June 3, 2022

RE: St. Lucie Plant Units 1 and 2
Dockets 50-335 and 50-389
Renewed Facility Operating Licenses DPR-67 and NPF-16

License Amendment Request, Revision 1 to the Technical Specifications Conversion to NUREG-1432, Revision 5

Figure 3.3.1-3

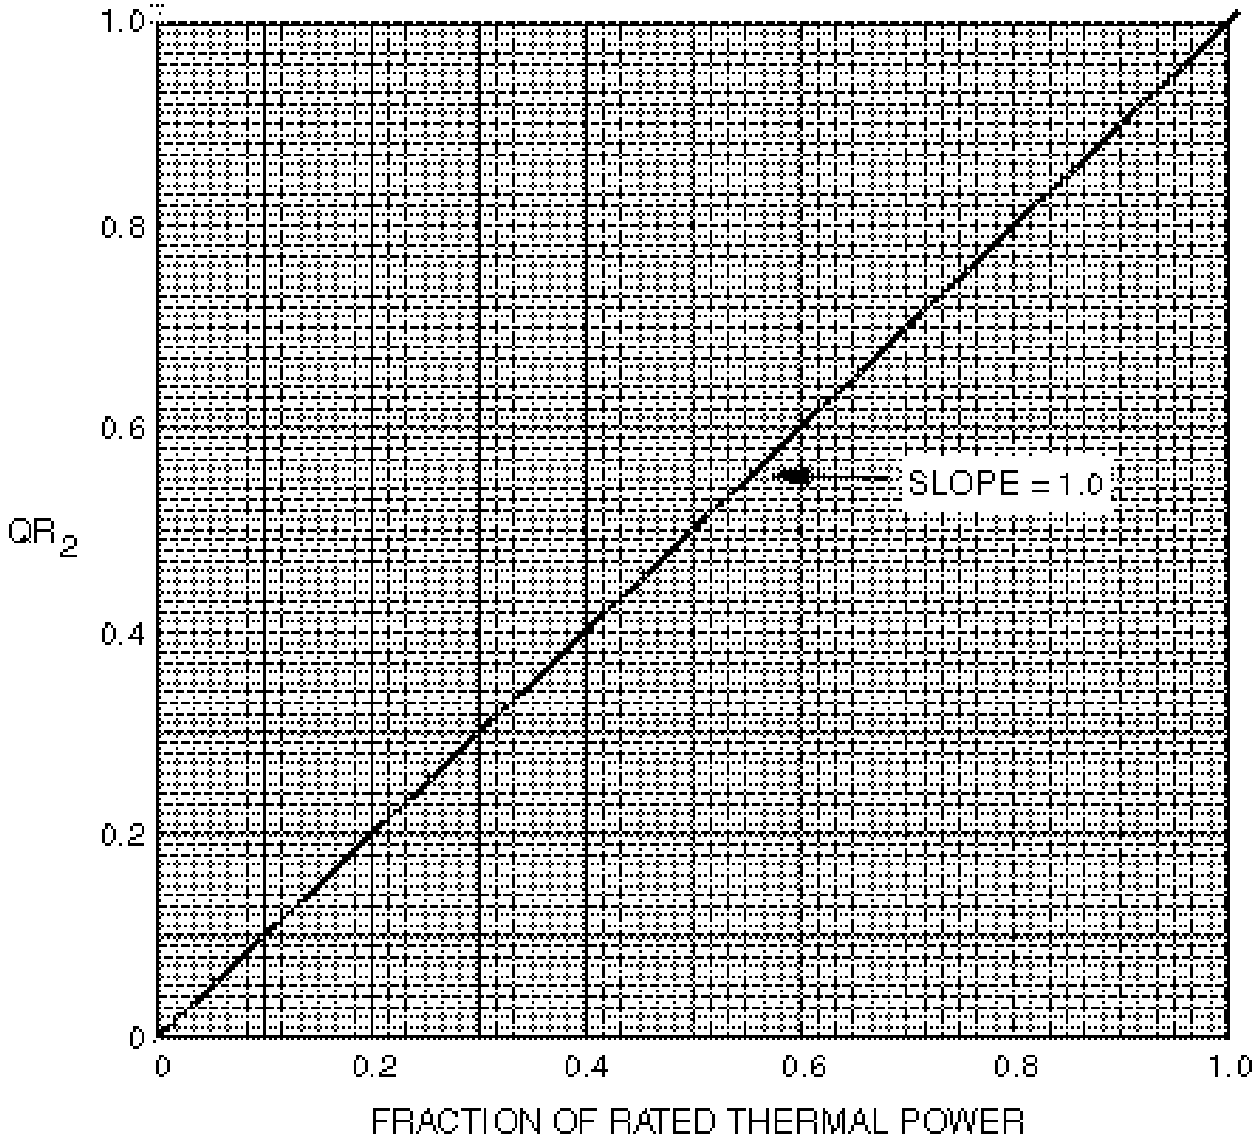
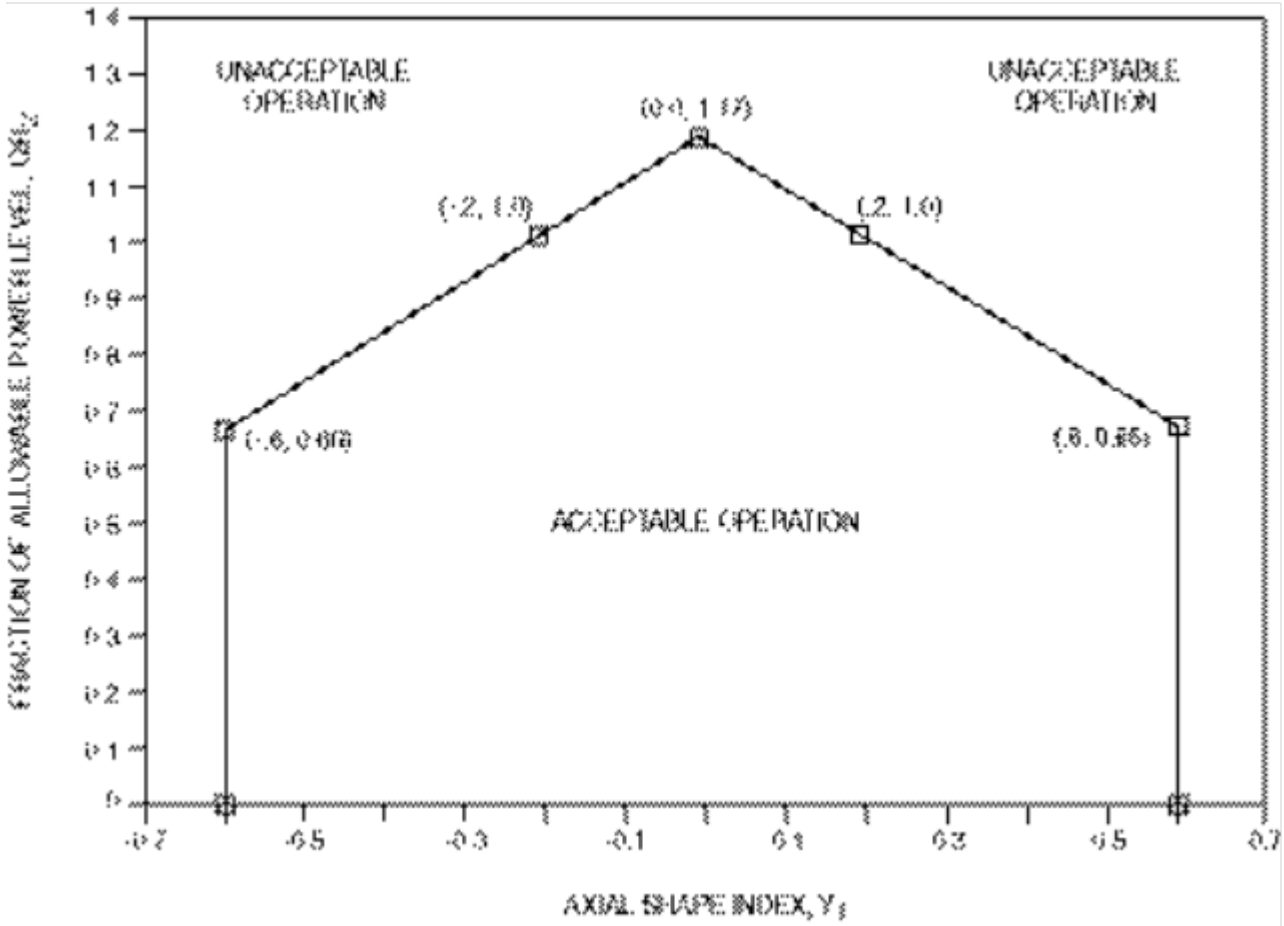
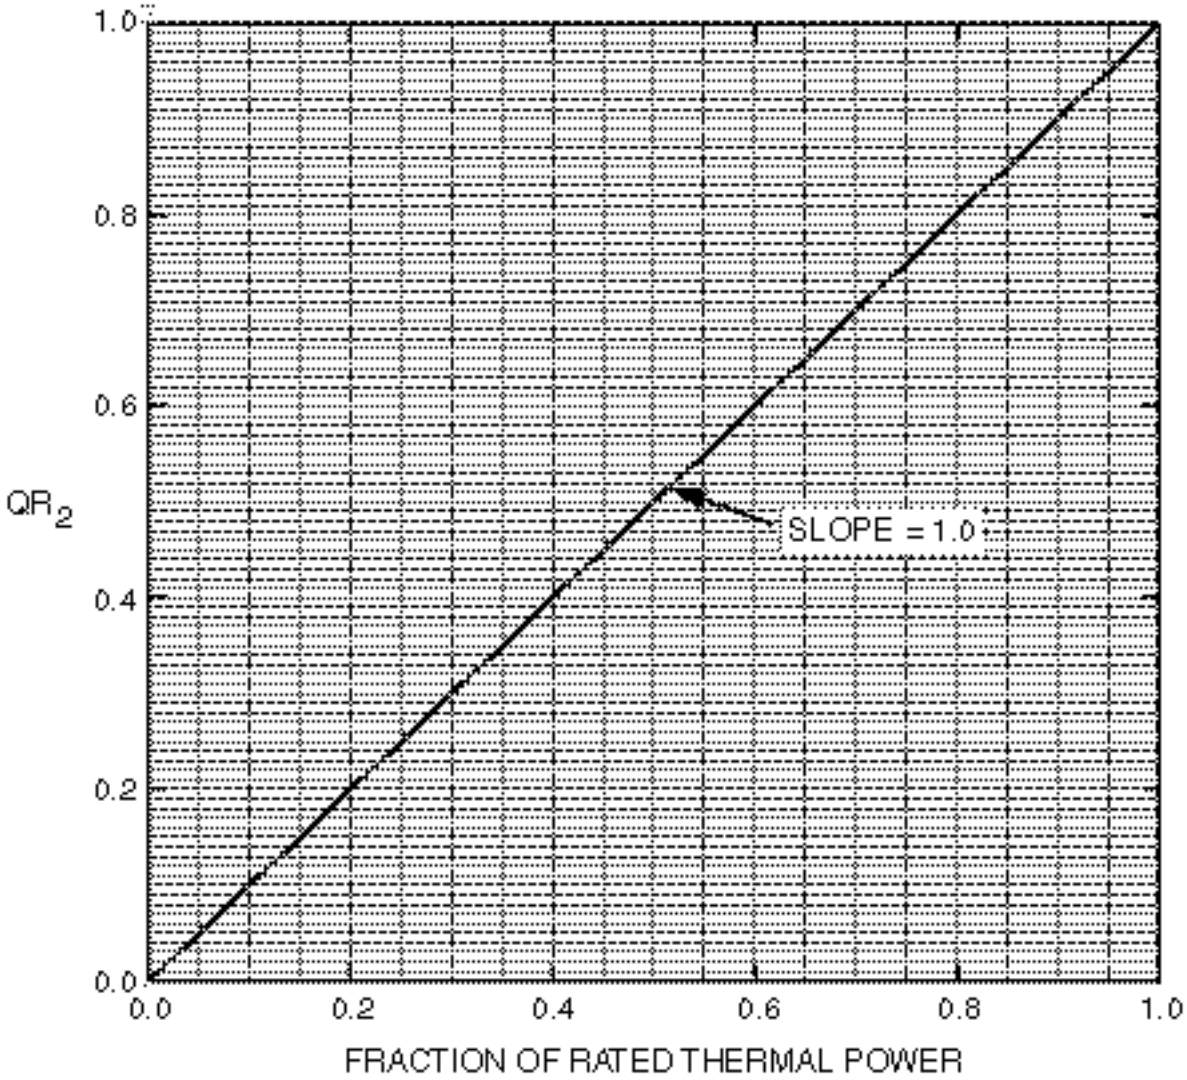
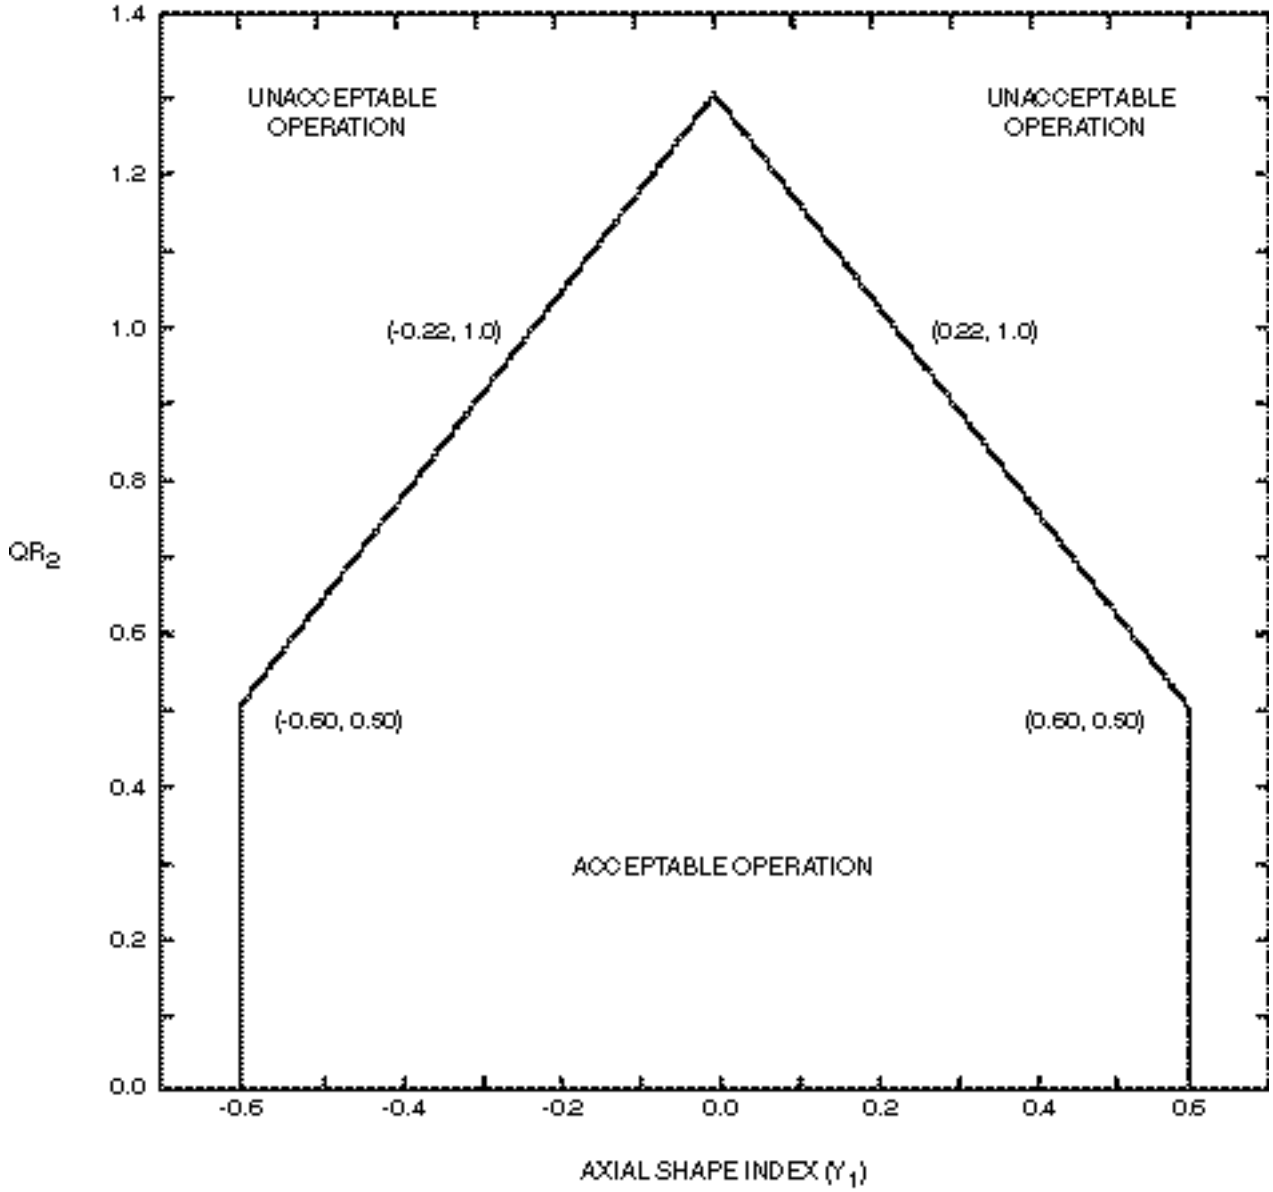
1. On pages 68, 69, 80, and 81/450, Both Units – The ITS say to insert figure 2.2-1, but there does not appear to be adequate space on the page. If another page is added the page

numbering will be incorrect. Also figure 3.3.1-3 on ITS page 3.3.1-12 (taken from CTS figure 2.2-2) is labeled page 1 of 1, but it appears to be page 2 of 2. Figure 2.2-1 appears to be page 1 of 2.

No change is made to the submittal. The CTS Figure inserts listed herein correlate the CTS Figures to the ITS Figure 3.3.1-1, ITS Figure 3.3.1-2, and ITS Figure 3.3.1-3, as applicable. ITS Figure 3.3.1-3, as indicated, will contain two pages.

- CTS Figure 2.2-3 will be ITS Figure 3.3.1-1 (Page 1 of 1),
- CTS Figure 2.2-4 will be ITS Figure 3.3.1-2 (Page 1 of 1),
- CTS Figure 2.2-1 will be ITS Figure 3.3.1-3 (Page 1 of 2), and
- CTS Figure 2.2-2 will be ITS Figure 3.3.1-3 (Page 2 of 2).
